Upper Berryessa Creek Flood Risk Management Project Santa Clara County, California

Final Environmental Impact Report

January 2016

Figure 2.4 100-Year Flood Zone

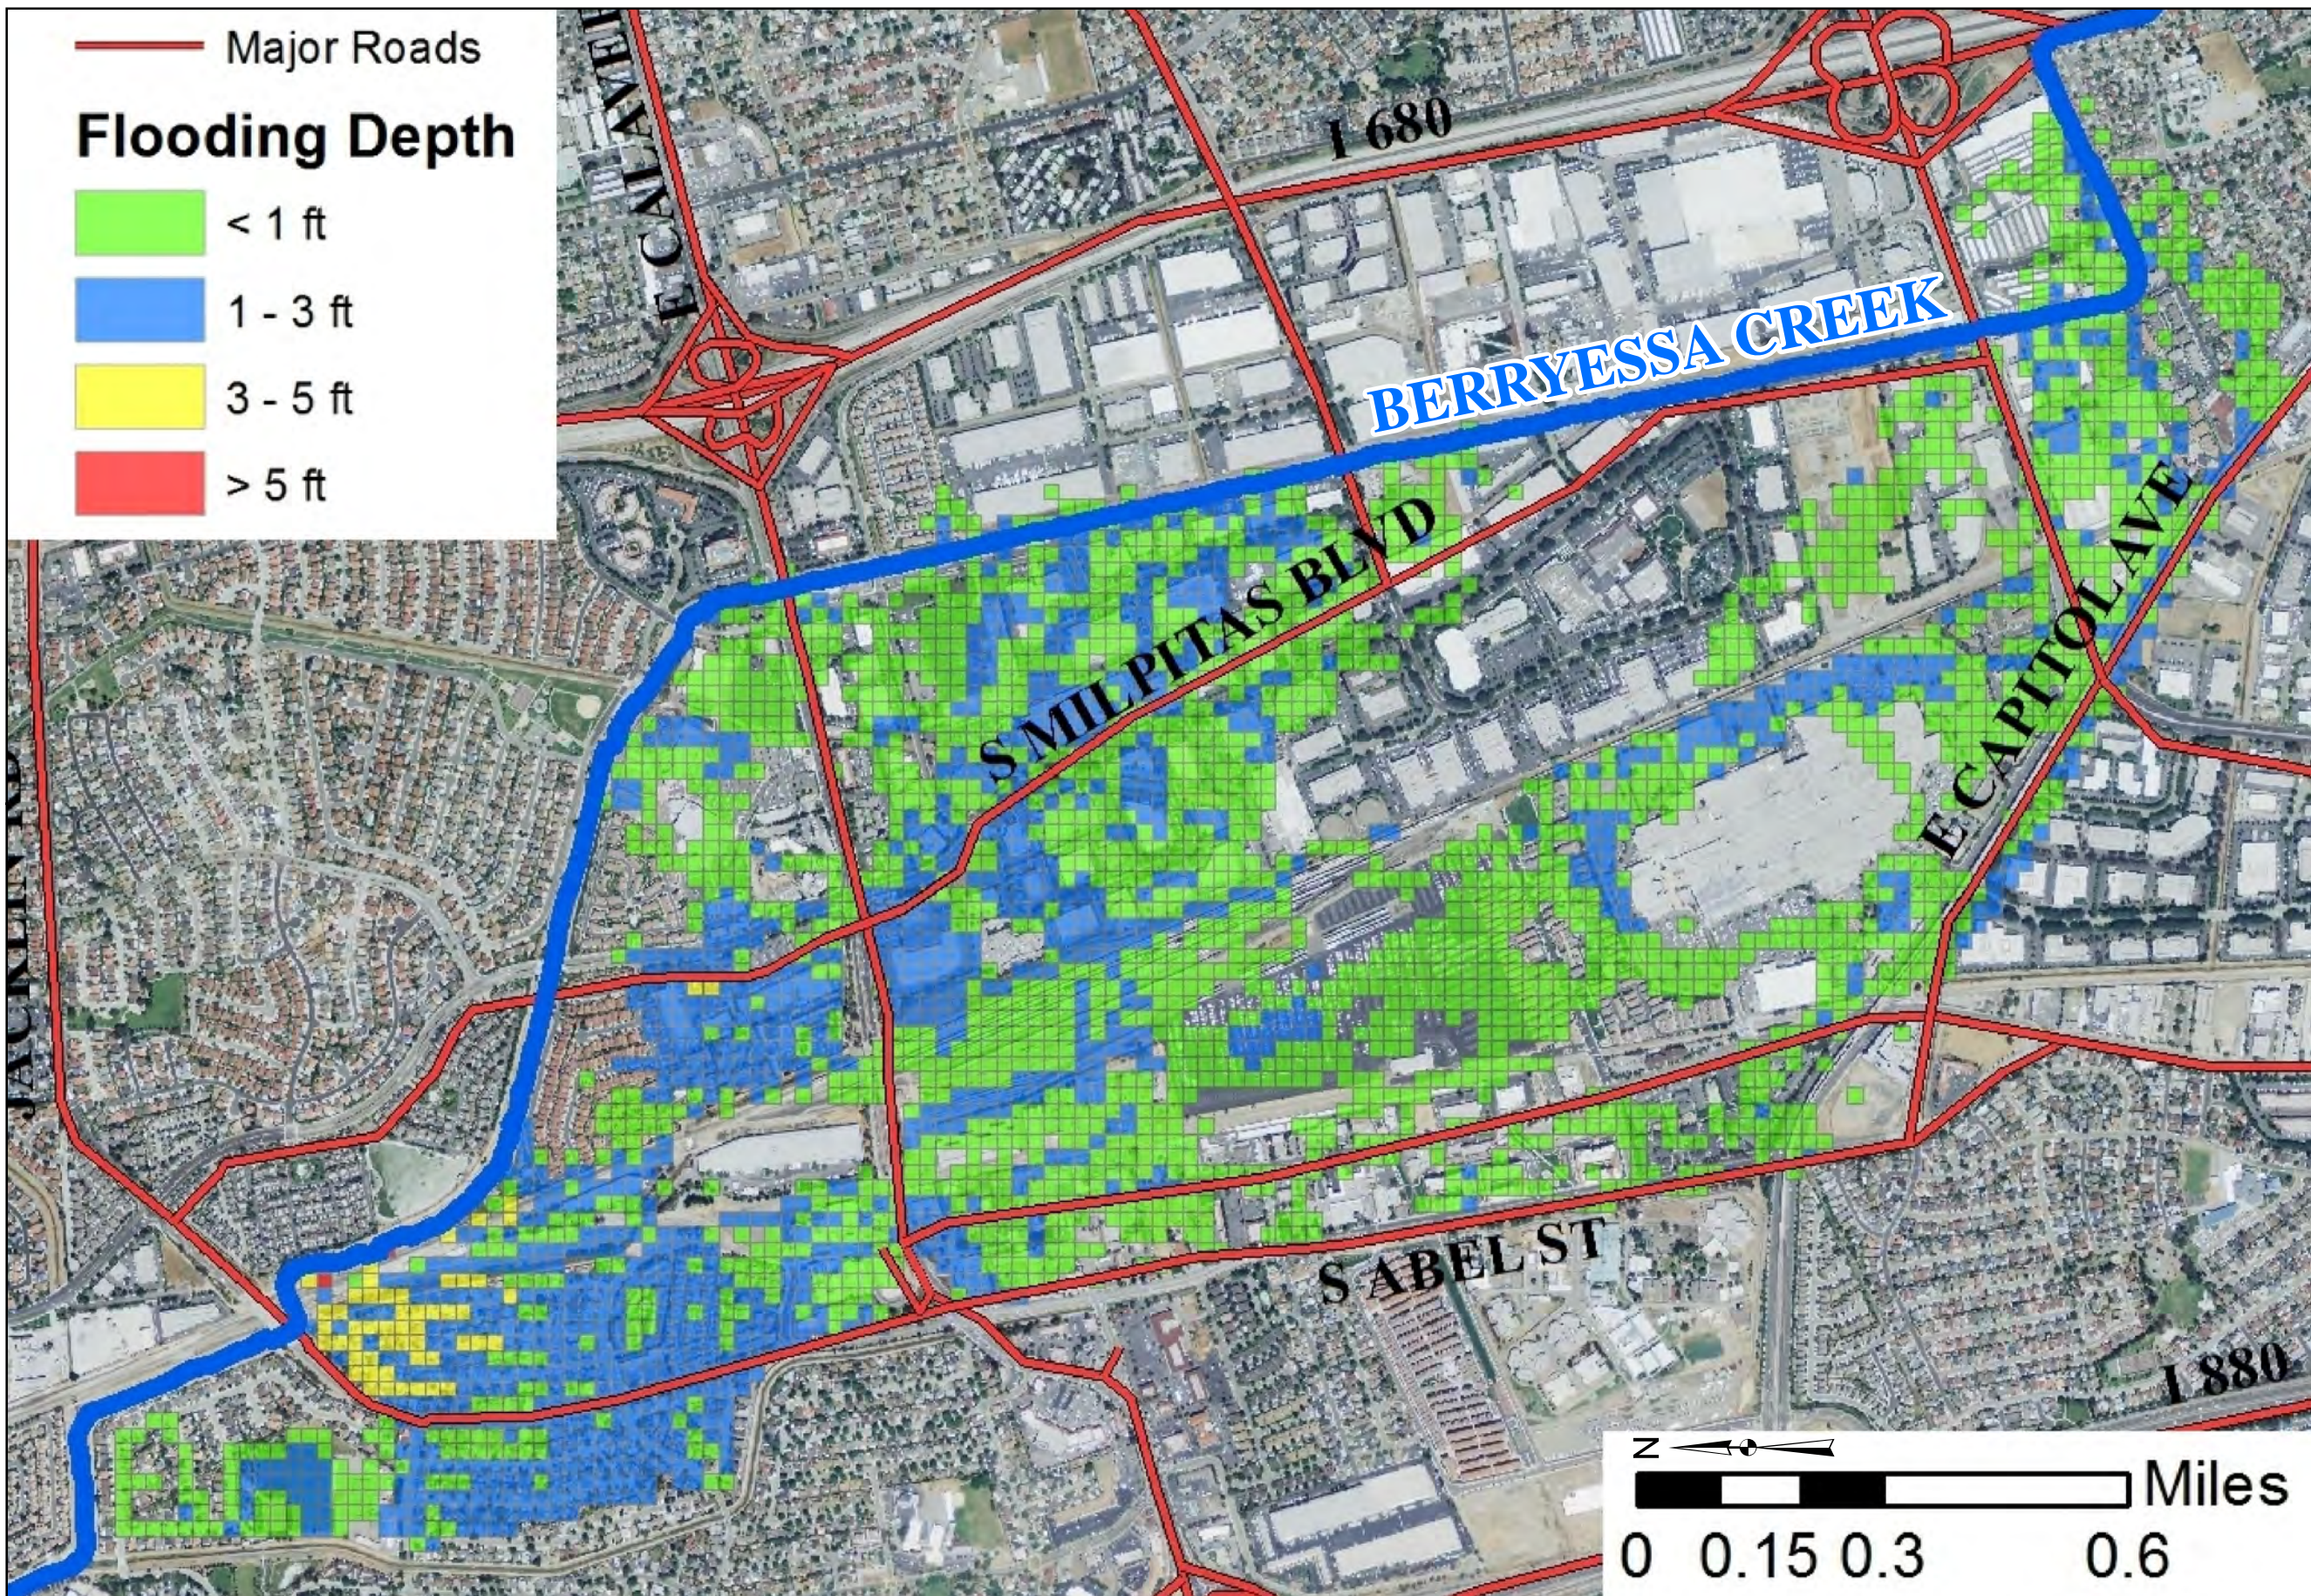
Page 3-190 of Section 3.17.2.2. Hydrology and Flooding: This section describes the existing conditions as "there is essentially no floodplain" for Reaches 1-3 and "almost complete disconnection from the floodplain" for Reach 4. Based on Figure 2.4, it appears that the floodplain mainly contained in the channel and overtops to the surrounding area with the depth less than 1 foot during a 100 yr. flood event.

Figure 2.4 shows the areas that would be flooded during the 100-year event under current creek conditions (i.e., without implementation of the proposed project). The 100-year flood zone shown in Figure 2.4 is based on modeling conducted during preparation of the USACE's Feasibility Study/GRR and differs somewhat from the FEMA flood hazard areas because of the availability of more recent hydrology and modeling results. Figure 2.5 (a new figure included in the Final EIR) shows the existing FEMA Special Flood Hazard Areas in the project area and the areas that would be removed from the flood hazard zone if the proposed project were implemented. The proposed project would remove about 650 parcels from the FEMA flood hazard area (see Figure 2-5).

Figure 2.8 Proposed Project Typical Sections

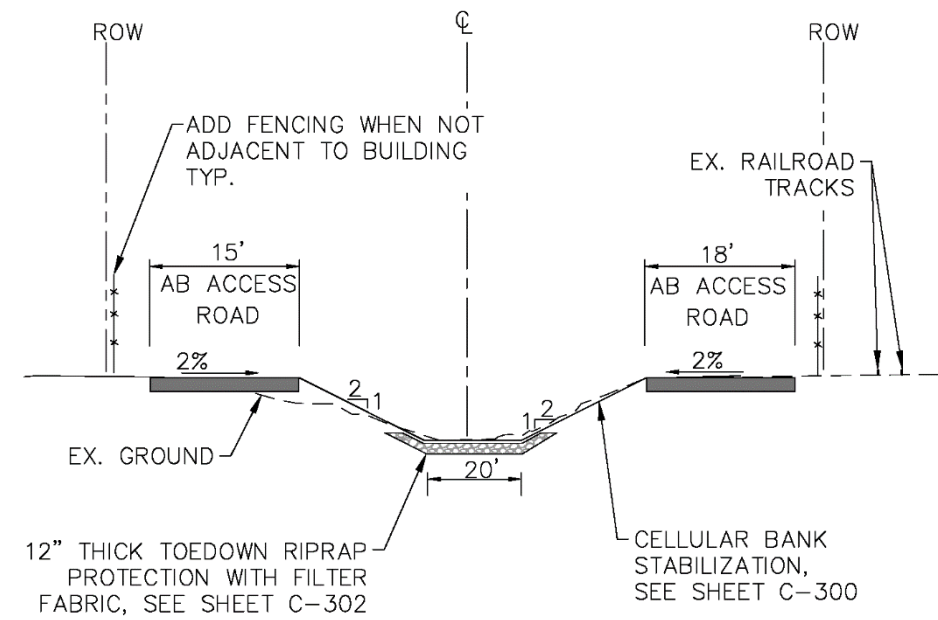
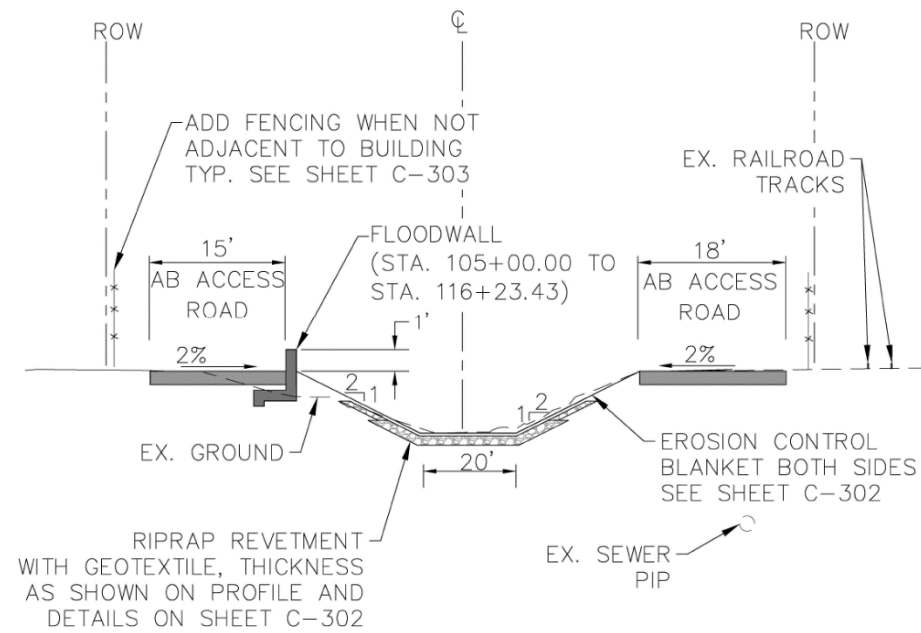
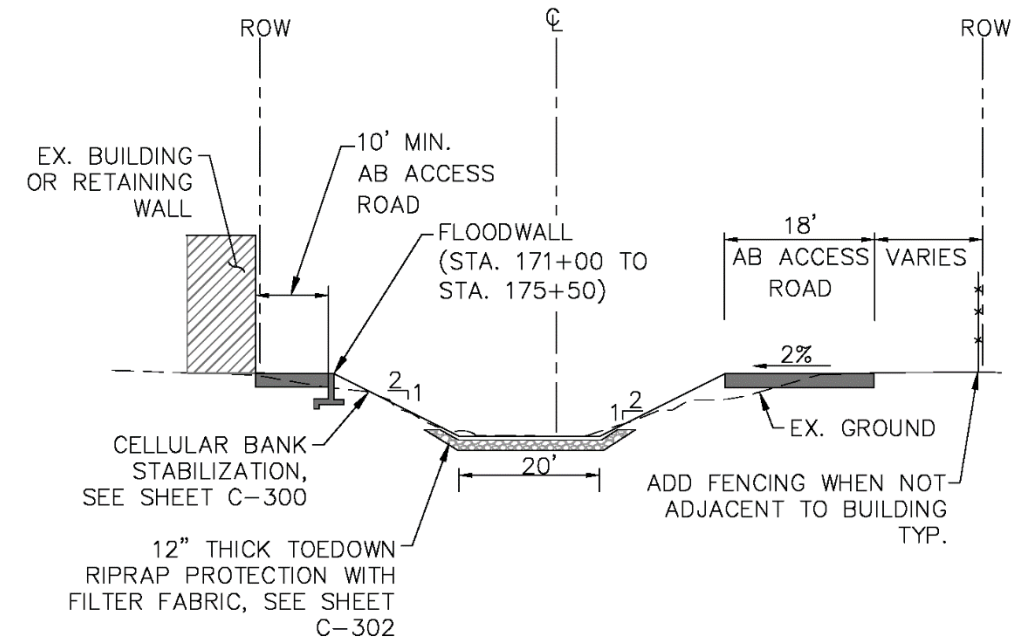
Floodwall Cross Sections: Please clarify whether the corresponding floodwall typical cross sections have been updated to include the new wall extension. The original proposed floodwall will be extended from 1,300 feet (-ft) to 2200-ft along the west bank in Reaches 2 and 3 with a wall extension from "roughly the Piedmont Creek confluence to 1,500 feet upstream of Los Coches street". Figures 5.1, 5.2 and 5.3 show the original typical cross sections for alternatives 2A, 2B and 4. Figure 2.7 .shows the typical cross sections for the revised project. It appears both Figures 2.7 and 5.1 show the same floodwall limits unchanged from stations 103+50 to 116+23.43 (1273-ft).

Figures 2.7 and 5.1: Please clarify why the 450-ft second floodwall in Reach 4 (171+00 to 175+50) was shown on Figure 5.1 (Alternative 2A sections, south of Montague Expressway) but not on the revised typical cross sections of Figure 2.7.

Figure 5.1 shows representative cross sections of Alternative 2A, which is USACE's selected alternative plan. The proposed project design is identical to Alternative 2A except that in Reaches 2/3 the proposed project includes a longer and taller concrete floodwall (approximately 2,200 feet long and up to 2 feet tall) than Alternative 2A. Under Alternative 2A the floodwall would be approximately 1,300 feet long and 1.5 feet high. Figure 2.7 has been revised and renumbered as Figure 2.8, and now contains a cross-section showing the proposed project floodwall.

The Reach 4 floodwall was inadvertently omitted from Figure 2.7 in the Draft EIR. Figure 2.7 (now Figure 2.8 in the Final EIR) has been revised to include the buried floodwall in Reach 4.
